**ALLIANCE FOR NUCLEAR RESPONSIBILITY**

June 4, 2012

I write to update you on the latest developments from PG&E's Reply Brief filed June 1, 2012 in the CPUC's A.10-01-014 proceeding. Consistent with the witness stand testimony of Dr. Stuart Nishenko cited in A4NR's May 3, 2012 written comments on the DEIR, the utility appears to have agreed that its seismic studies should cover the onshore and offshore terrain recommended by Dr. Douglas Hamilton.

**Figure 1.** Alternative 3D Marine HESS Racetrack, plan submitted to CA SLC by PG&E January 2012, with suggested revised 3D Marine HESS Racetrack panels and on-land 2D Vibroseis lines plotted.

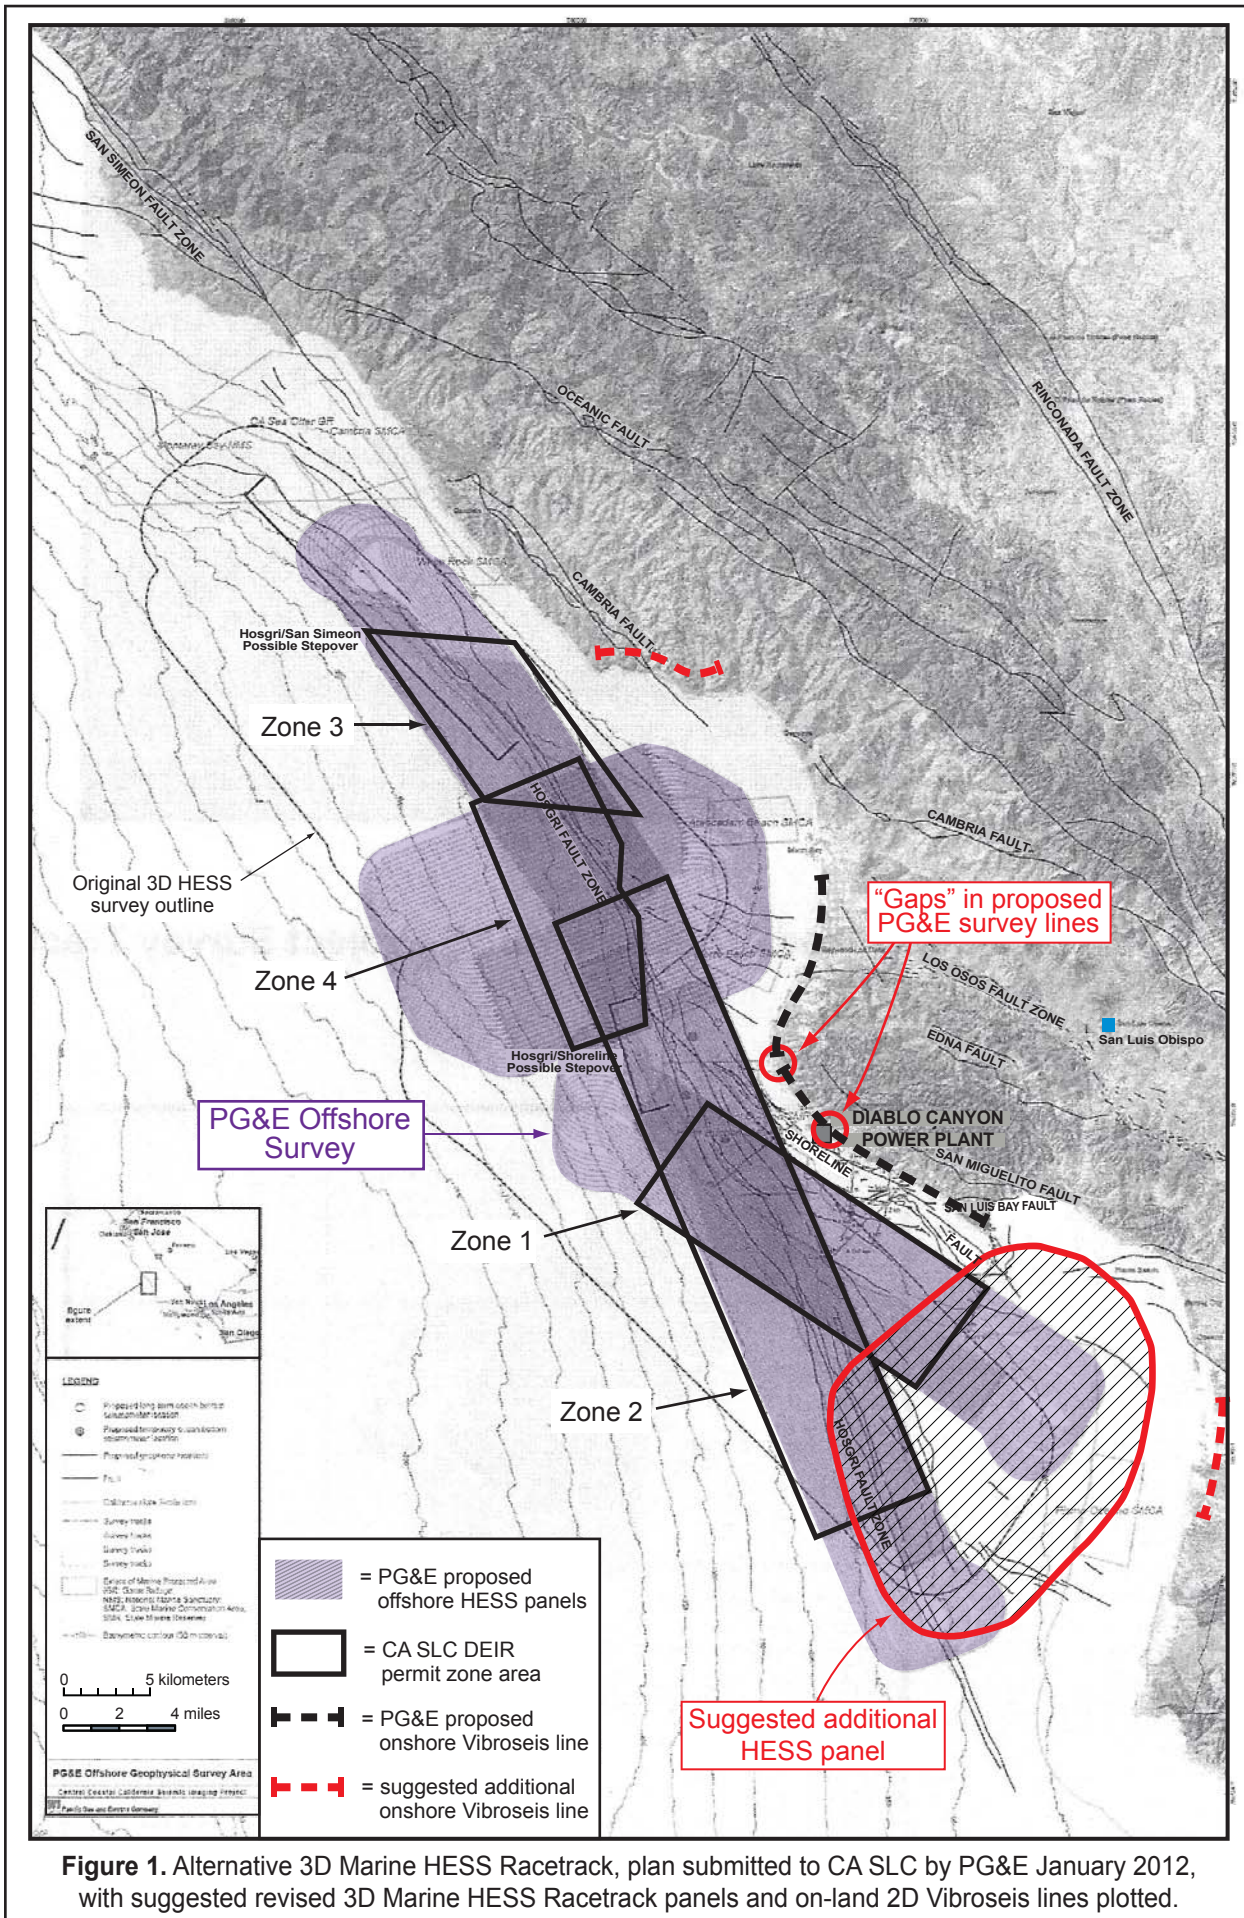
**A4NR respectfully asks the State Lands Commission to require PG&E to specifically delineate the changes in its offshore and onshore study plans necessary to gather data to fully assess the "missed fault" recommendations of Dr. Douglas Hamilton, as graphically mapped in the DEIR comment submitted by geologist Erik Layman.**
